**City of Bellevue  
Development Services Department  
Land Use Staff Report**

**Proposal Name:** Butte Short Plat

**Proposal Description:** Application for Preliminary Short Plat approval to subdivide an existing 21,924 square foot lot (0.50 acre) into 3 single-family lots, located in the R-5 land use district.

**File Number:** 15-125885-LN

Figure 1 – Preliminary Short Plat Proposal

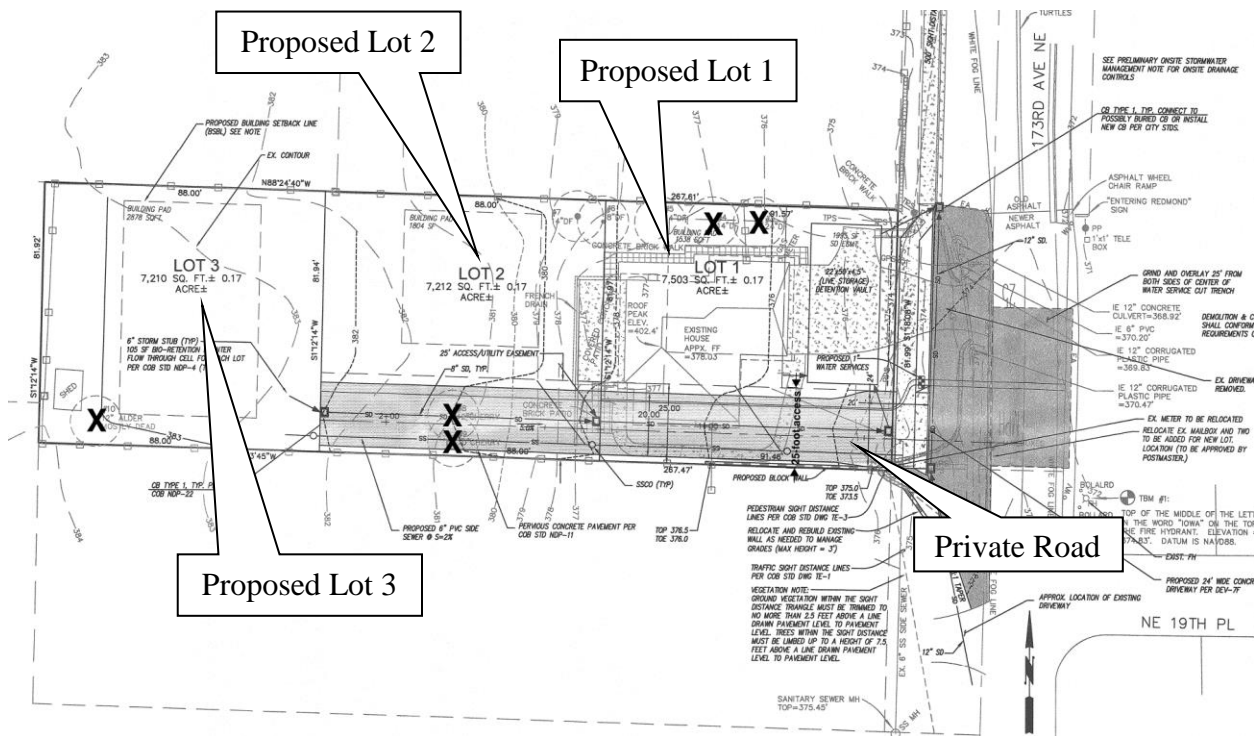
The applicant's originally proposed a 2-lot short plat with a desired access location along the north property line. The proposed access location would necessitate the removal of mature conifers and the partial demolition of the existing home due to the required 10-foot setback from the access easement. The city requested that the applicant locate the driveway along the south property line to preserve desirable trees and comply with LUC 20.20.900.

The applicant's realization that the home would need to be partially demolished in order to meet the required setback from the access easement made the applicant reconsider retaining the existing home and instead proposed a 3-lot short plat rather than a 2-lot short plat.

A proposal for a 3-lot short plat was submitted to the City on August 8, 2016. The plan retains mature and healthy trees to comply with LUC 20.20.900.
